Access Compliance Report Public Rights-of-Way (Curb Ramps)

Main Street: SMOKE_TREE_DR		Cross Street: CAMERONS_WAY		Location:	E
ADA ID: RPAT211102154447	Ramp Type: Type 4 - Parallel	Initial Pass/Fail: Fail	Overall Compliance: No	Severity Score:	16

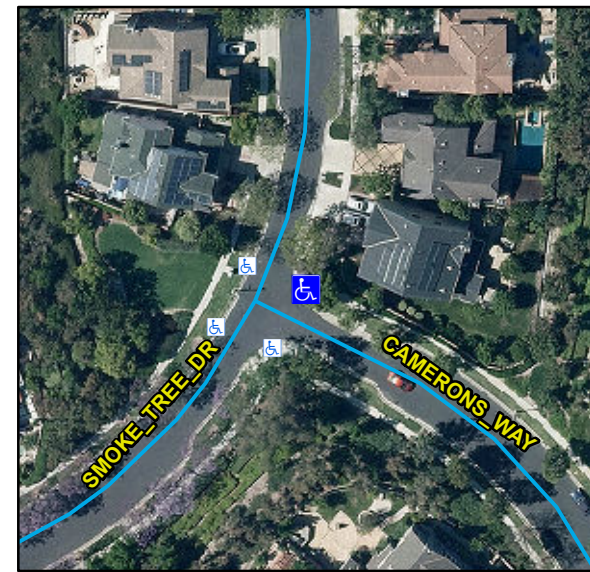
Compliance	Description	Data	Compliance	Description	Data
N/A	Ramp Length LT (in)	120	N/A	Ramp Length RT (in)	95
Yes	Ramp Width LT (in)	51	Yes	Ramp Width RT (in)	51
Yes	Ramp Run Slope LT (%)	4.4	No	Ramp Run Slope RT (%)	8.4
Yes	Ramp Cross Slope LT (%)	1.6	No	Ramp Cross Slope RT (%)	4.2
N/A	Landing Present	N/A	N/A	DWS Provided	N/A
N/A	Landing Length (in)	N/A	N/A	DWS Contrast	N/A
N/A	Landing Width (in)	N/A	N/A	DWS Length (in)	N/A
N/A	Landing Run Slope (%)	N/A	N/A	DWS Full Width	N/A
N/A	Landing Cross Slope (%)	N/A		DWS Offset Type	N/A
N/A	Landing Movement Obstructed?	N/A	N/A	DWS Offset Left (in)	N/A
	Landing Movement Type	N/A	N/A	DWS Offset Right (in)	N/A
N/A	Landing Shared	N/A			
N/A	Clear Space	Yes			
N/A	Clear Space To Crosswalk (in)	N/A			
N/A	Marked Crosswalk 1	No	N/A	Marked Crosswalk 2	No
	Crossing 1 Direction	NW		Crossing 2 Direction	SW
N/A	Marked Crosswalk 1 Width (in)	N/A		Marked Crosswalk 2 Width (in)	N/A

N/A	Ramp Inside Crosswalk 1	N/A	N/A	Ramp Inside Crosswalk 2	N/A
	Crossing 1 Slope (%)	0.4		Crossing 2 Slope (%)	2.1
	Crossing 1 Cross Slope (%)	1.8		Crossing 2 Cross Slope (%)	4
N/A	Gutter Ponding	N/A	N/A	Curb Slope	16.4
Yes	Gutter Lip Height (in)	0		Road Run Slope (%)	0.1
N/A	Gutter Run Slope (%)	N/A		Road Cross Slope (%)	2.1
N/A	Gutter Cross Slope (%)	N/A	No	Perpendicular Joint Present	No
Yes	Overall Surface Condition	Acceptable			
	Cross Gutter Present?	No		Spandrel Present?	No
	Replace Cross Gutter?	N/A		Replace Spandrel?	N/A

Remove & Replace Curb Ramp With Two New Directional Ramps or Equivalent.

R204.3, R304.3.2, R304.5.3, STD 1115
